**CITY OF  
PARRAMATTA**

**City of Parramatta Council submission to Independent Planning Commission  
Re: Amending Detailed Design & Amending Concept State Significant Development  
Applications, 242-244 Beecroft Road Epping (SSD-68939460 & SSD-68708456)**

## **Attachment A: Detailed Submission**

**Figure 1:** Proposed traffic solutions, Draft Epping Town Centre Masterplan 2025 (Source: <https://www.cityofparramatta.nsw.gov.au/about-parramatta/news/on-exhibition/epping-town-centre-master-plan>)

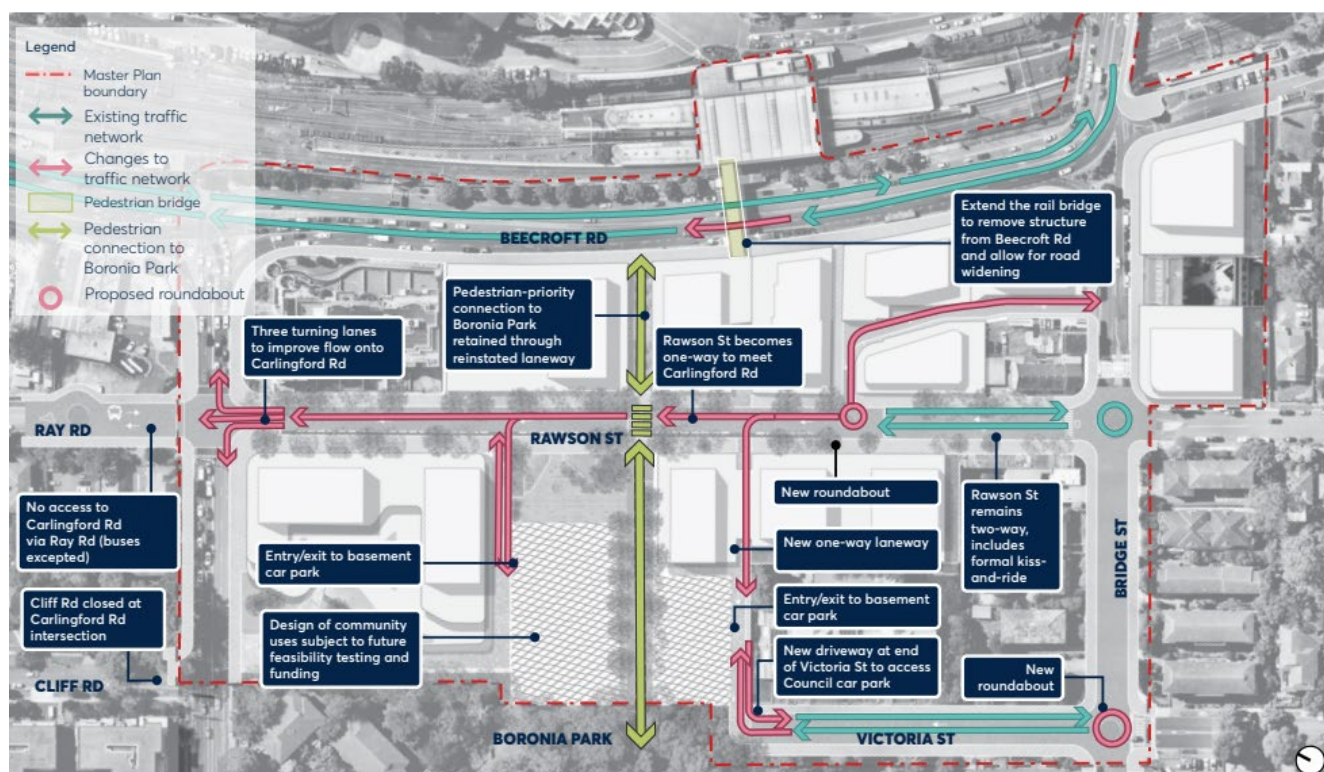
At the Council meeting held on 14 July 2025, Council resolved to approve a draft masterplan for the Epping Town Centre for the purpose of public exhibition. The draft masterplan aims to improve the traffic flow within Epping, particularly in Rawson Street, through the following measures:

1. Partial closure of Ray Road at Carlingford Road by removing access out of Ray Road at the intersection. This change will assist right turn movements from Rawson Street into Carlingford Road. This change will also require the signalisation of Carlingford Road and Kent Street which would be used by impacted residents in Ray Road to access Carlingford Road.

2. Changes to Rawson Street by introducing a partial one-way restriction which will allow for additional travel lanes at the intersection with Carlingford Road.

3. Construction of a new laneway linking Victoria Street to Rawson Street which will provide an alternative access to the Council carpark, and will allow better vehicle circulation and reduce the amount of traffic travelling to the Rawson Street and Carlingford Road intersection.

4. Construction of a new pedestrian bridge in Beecroft Road which will replace the existing bridge. This will require negotiation with Sydney Trains and the private landowner which Council would help facilitate. The proposal will improve traffic flow from Epping Road through to Carlingford Road by allowing for an additional travel lane.

**Figure 1** below summarises the proposed traffic solutions by Council.
